**AMENDMENTS TO THE DRAWINGS**

**REMARKS**

Application No.: 10/529,239  
Amdt. dated June 6, 2007  
Reply to Office Action dated March 8, 2007

Docket No.: 9988.219.00

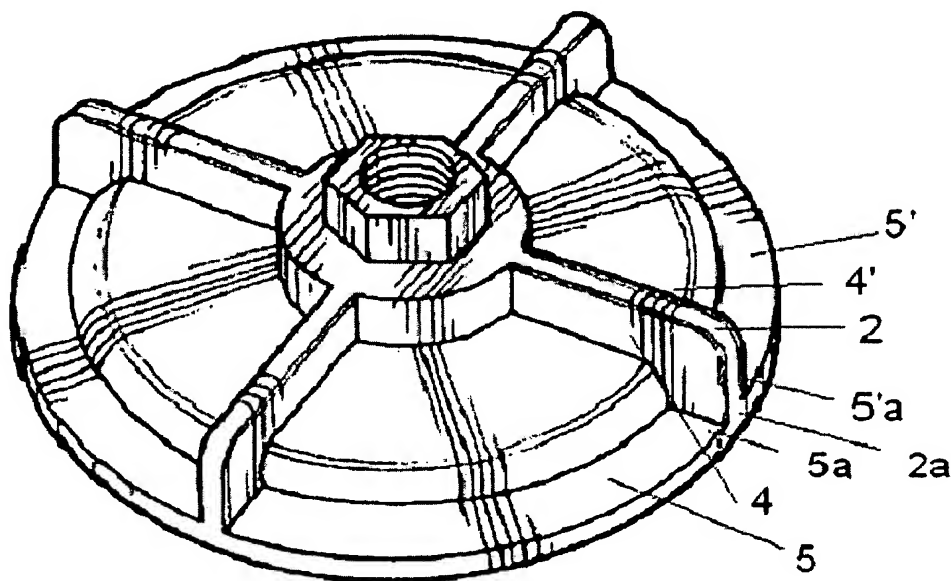
Instead, Nelson teaches the end (5a) of the member (5) and the end (5'a) of the member (5') are coupled with the rib (2) at same place of the end portion (2a) of the rib (2). The rib (2) has two sides (4 and 4'). See Nelson, Fig. 1, reproduced below with annotation. The two sides (4 and 4') of the rib (2) are symmetrical. That is, the two sides (4 and 4') are mirror images of each other. Accordingly, claim 1 is allowable over Nelson. Claims 2-21, which variously depend from claim 1, are also allowable over Nelson.

FIG. 1

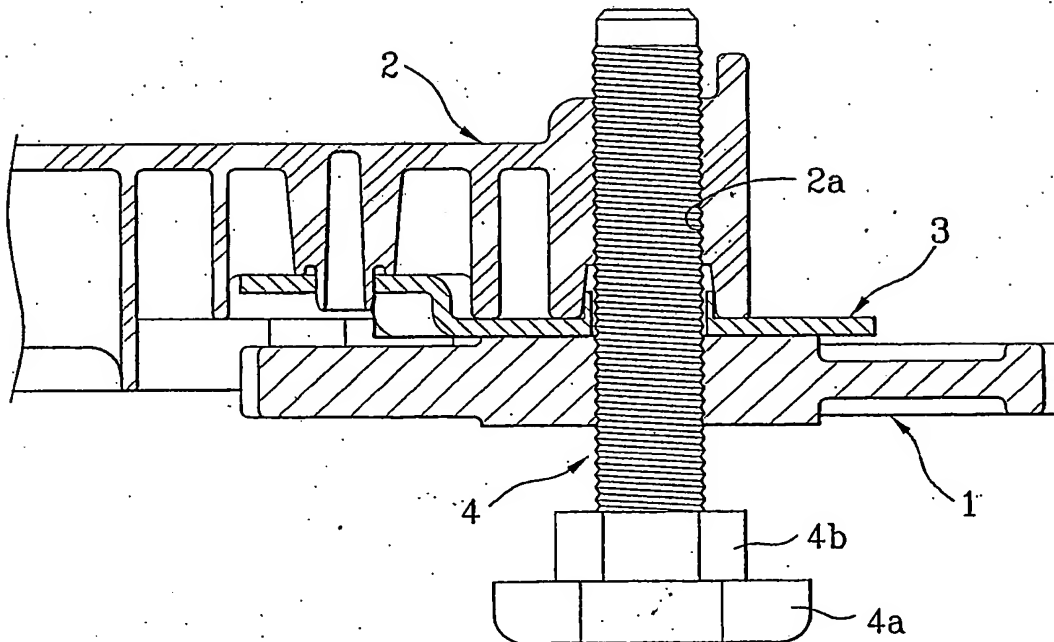
The attached sheet(s) of drawings includes changes to Figs. 1, 2, and 3. The sheets, which include Figs. 1-4, replaces the original sheet including Figs. 1-4. The term "Related Art" has been added to Figs. 1, 2, and 3.

The Office Action objects to the drawings for minor informalities. Applicants have corrected the drawings accordingly. Applicants, therefore, respectfully request the withdrawal of the objection.

-- RELATED ART --
